WHISMAN OVERPASS UTILITIES RELOCATION
PROJECT 65-30

SCALE: AS SHOWN | DATE: DEC. 1965 | SHEET 2 OF 4

CHANGE ORDER NO.
CENTRAL EXPRESSWAY UNIT NO. 2

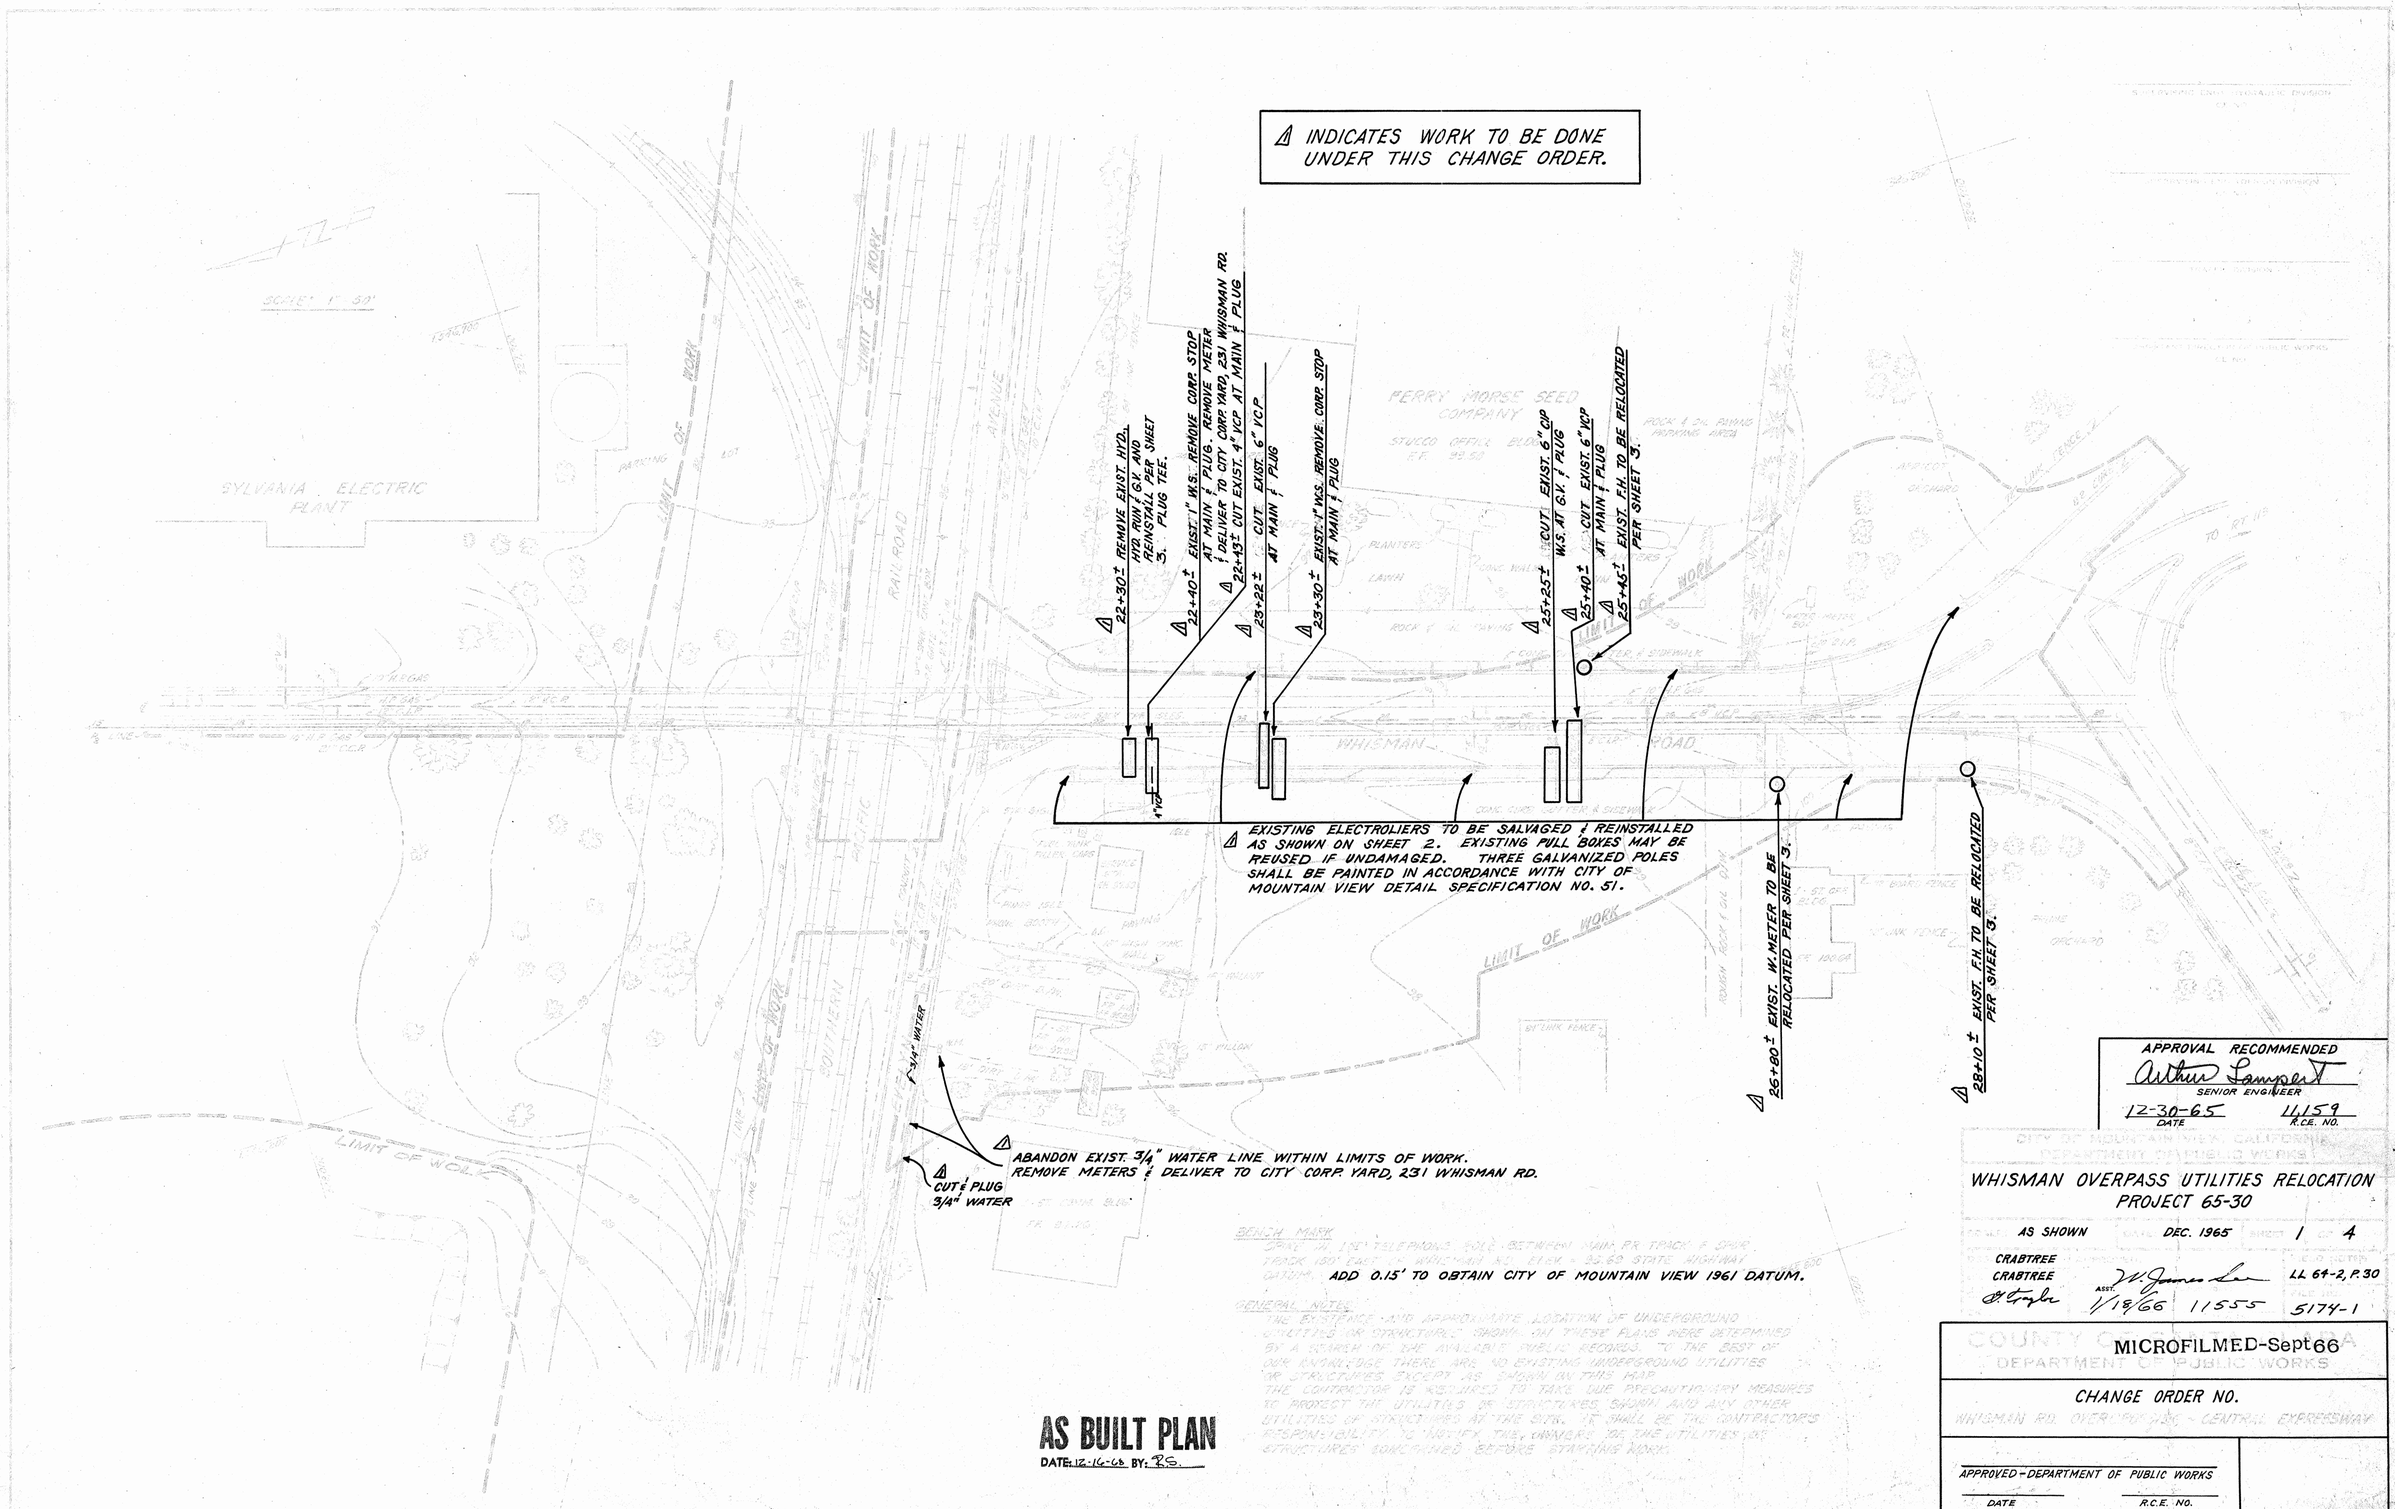
INDICATES WORK TO BE DONE UNDER THIS CHANGE ORDER.
22+30± REMOVE EXIST. HYD., HYD. RUN & G.V. AND REINSTALL PER SHEET 3. PLUG TEE.
22+40± EXIST. 1" W.S. REMOVE CORP. STOP AT MAIN & PLUG. REMOVE METER & DELIVER TO CITY CORP. YARD, 231 WHISMAN RD.
22+43± CUT EXIST. 4" VCP AT MAIN & PLUG
23+22± CUT EXIST. 6" VCP AT MAIN & PLUG
23+30± EXIST. 1" W.S. REMOVE CORP. STOP AT MAIN & PLUG
25+25± CUT EXIST. 6" CIP W.S. AT G.V. & PLUG
25+40± CUT EXIST. 6" VCP AT MAIN & PLUG
25+45± EXIST. F.H. TO BE RELOCATED PER SHEET 3.
26+80± EXIST. W. METER TO BE RELOCATED PER SHEET 3.
28+10± EXIST. F.H. TO BE RELOCATED PER SHEET 3.
EXISTING ELECTROLIERS TO BE SALVAGED & REINSTALLED AS SHOWN ON SHEET 2. EXISTING PULL BOXES MAY BE REUSED IF UNDAMAGED. THREE GALVANIZED POLES SHALL BE PAINTED IN ACCORDANCE WITH CITY OF MOUNTAIN VIEW DETAIL SPECIFICATION NO. 51.
ABANDON EXIST. 3/4" WATER LINE WITHIN LIMITS OF WORK. REMOVE METERS & DELIVER TO CITY CORP. YARD, 231 WHISMAN RD.

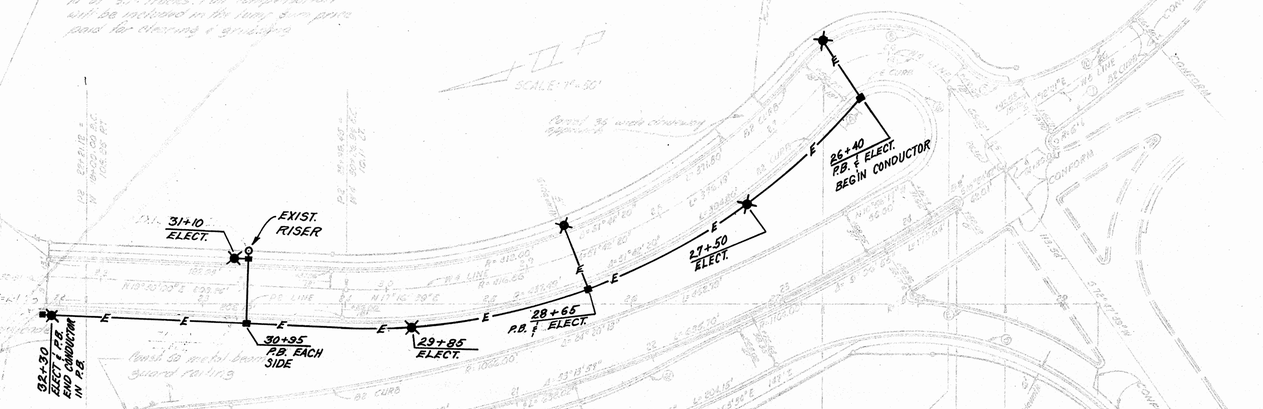
ELECTRICAL WORK SHOWN ON THIS SHEET TO BE DONE UNDER THIS CHANGE ORDER.

AS SHOWN	DATE DEC. 1965	SHEET 3	4
CRABTREE			
CRABTREE			LL 64-2, P30
	ASST. 1/18/66	11555	5174-3

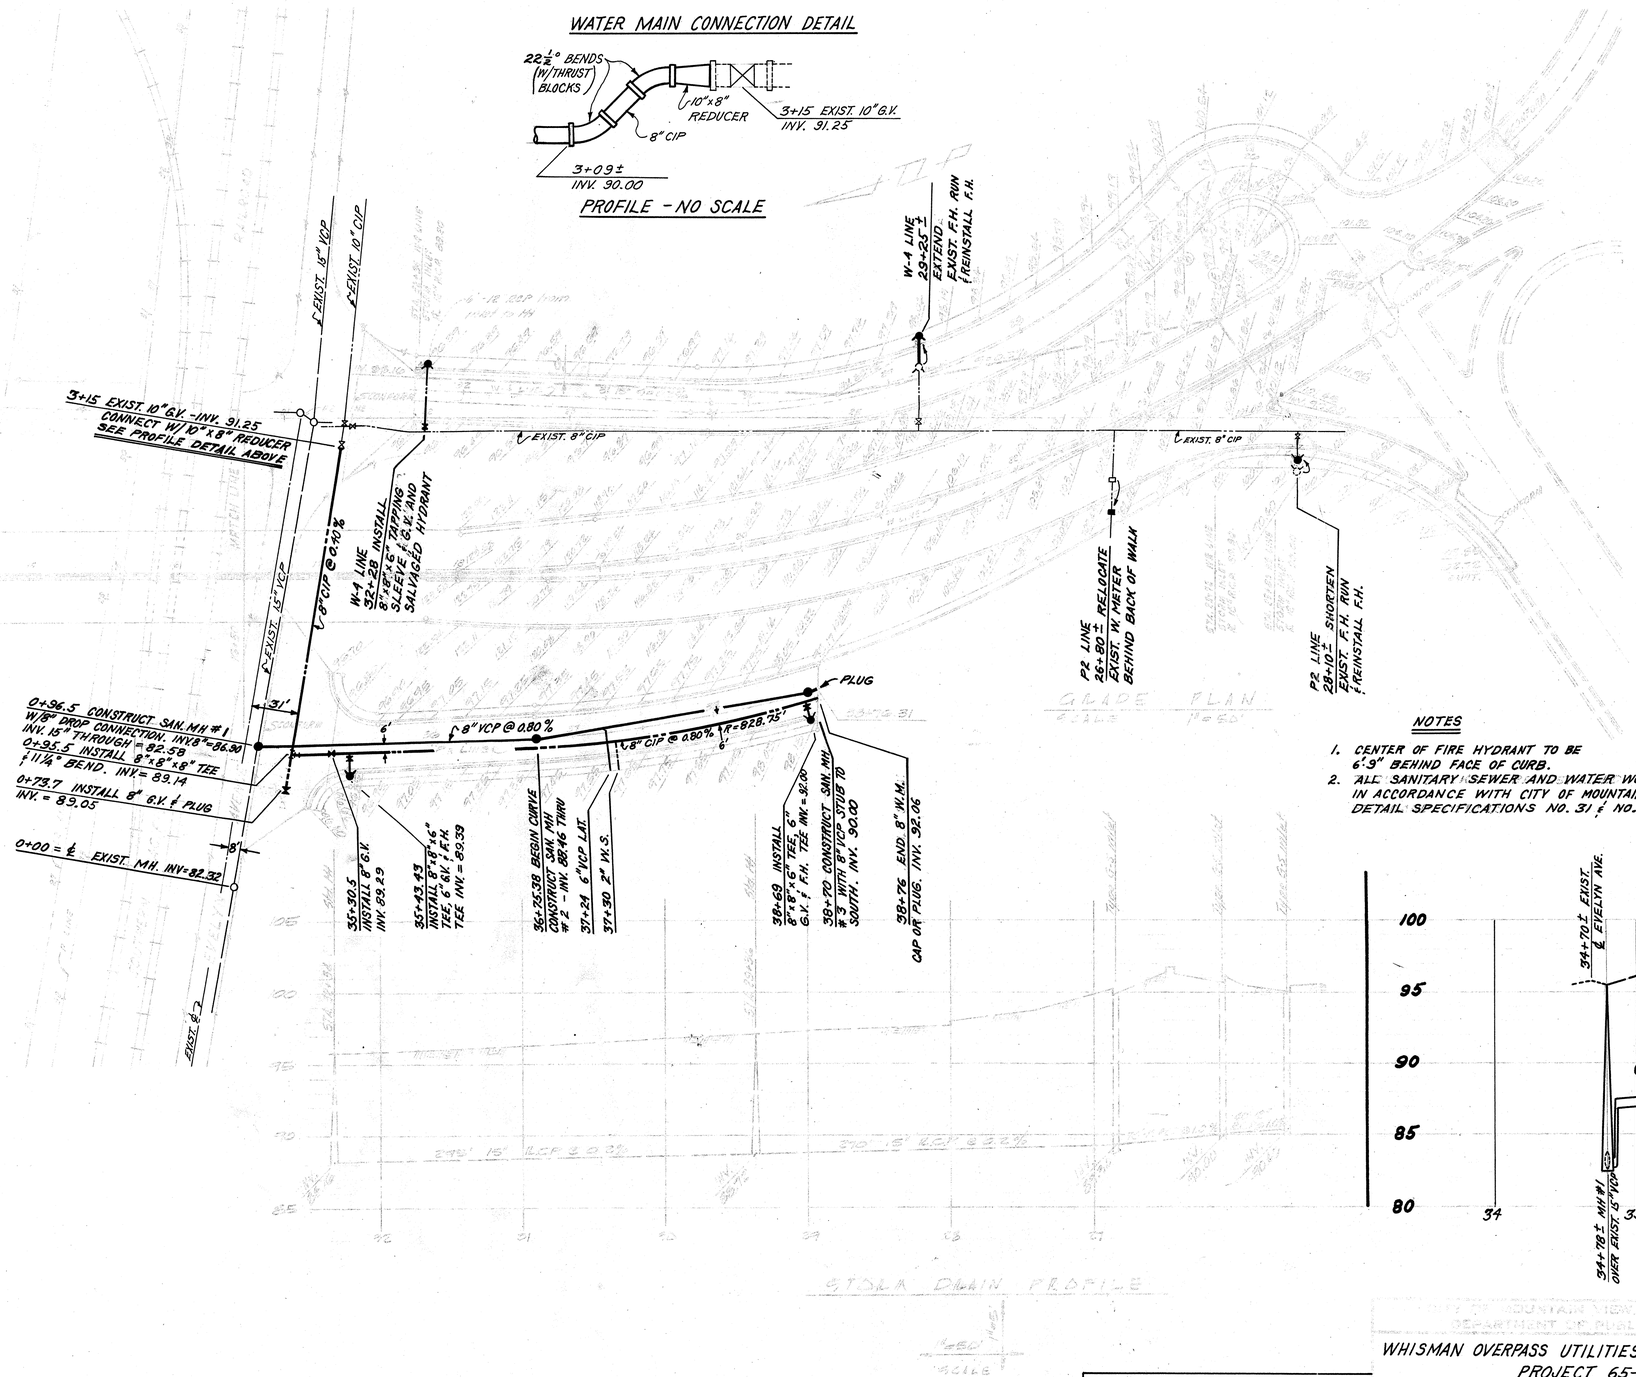
SANITARY SEWER AND WATER WORK SHOWN ON THIS SHEET TO BE DONE UNDER THIS CHANGE ORDER.

DR. BY: EJH DATE: 4-69	APPROVED ON 5-21-69	JOB NO. 66160	SHEET 13A
CKD. BY: SLH DATE: 5-69	BY		OF
SCALE: HORIZ. 1" = 50'	RE NO. 14392	FILE NO. IP621

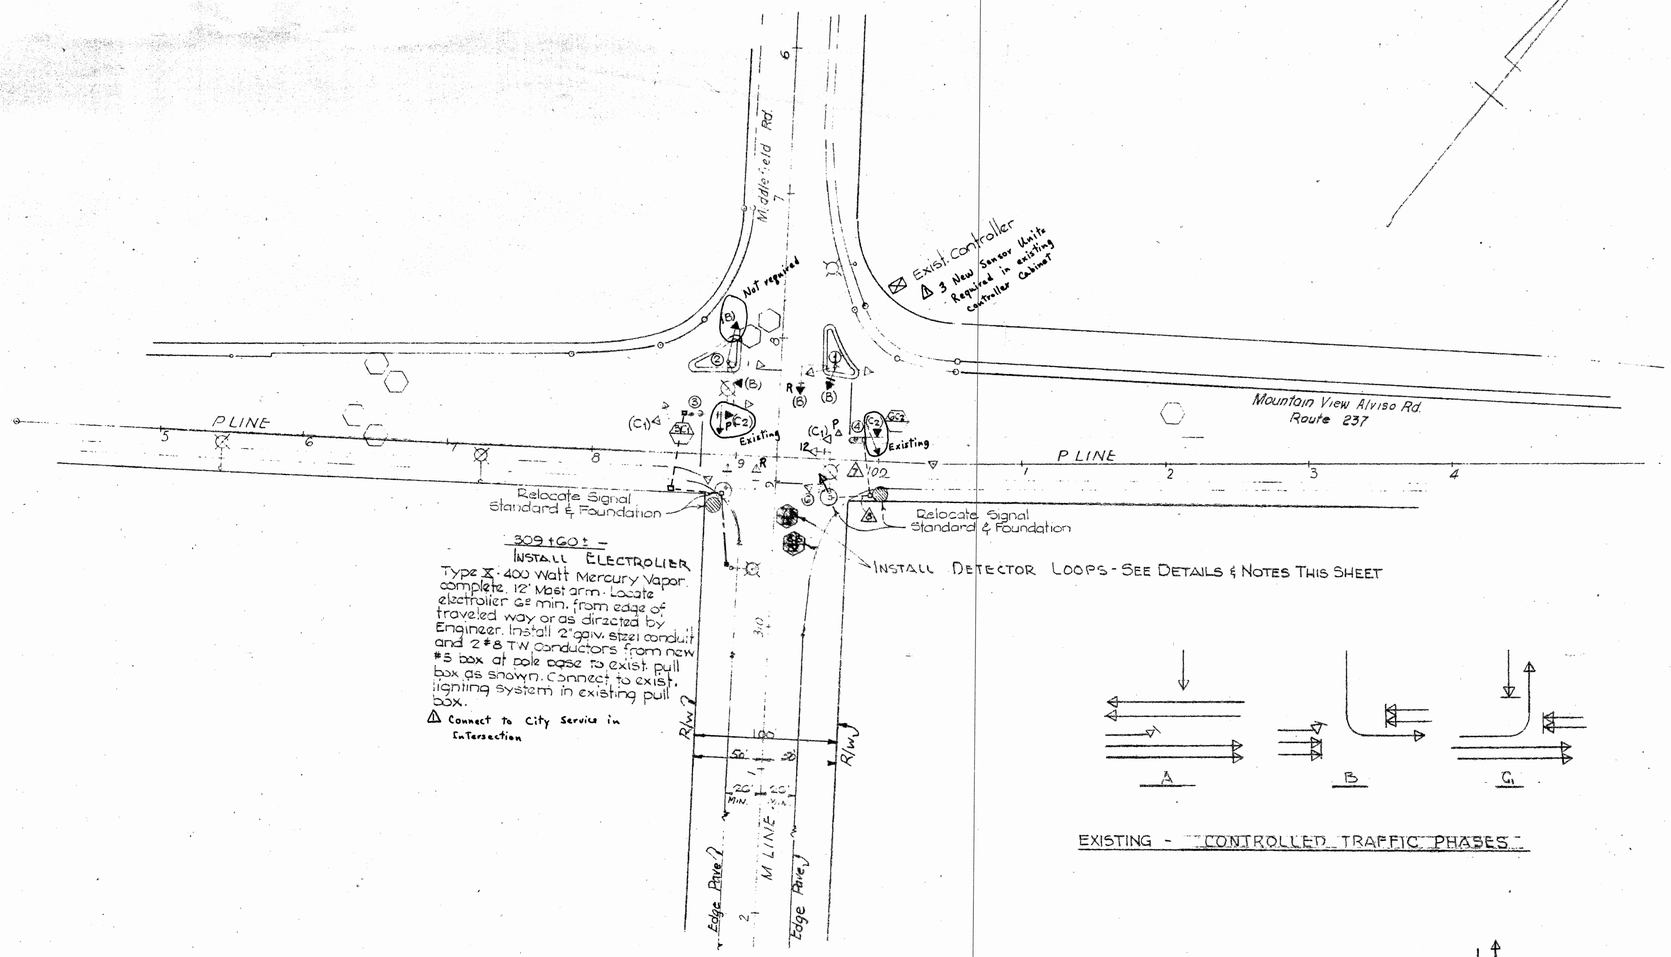
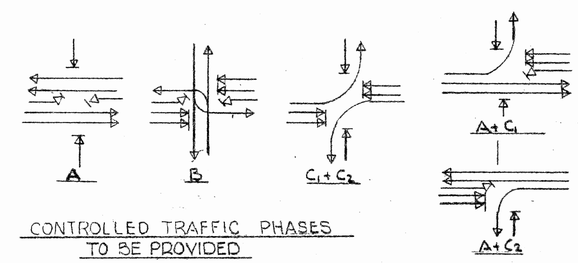
Furnish & install (In exist. Controller Cabinet) Detector Sensor units for Loops 7B, 8B and 6C2 (3 required).

Install detector cables for loops 7B & 8B in conduit run △ and connect to spare cables in run △.

Terminate leads for loops 7B & 8B in existing pull box at location ⓒ

△ Rev. 3 Sensor Units req'd.; Service to elect. at Sta. 309+60; Ex. signals in intersection 11-13-70 EM
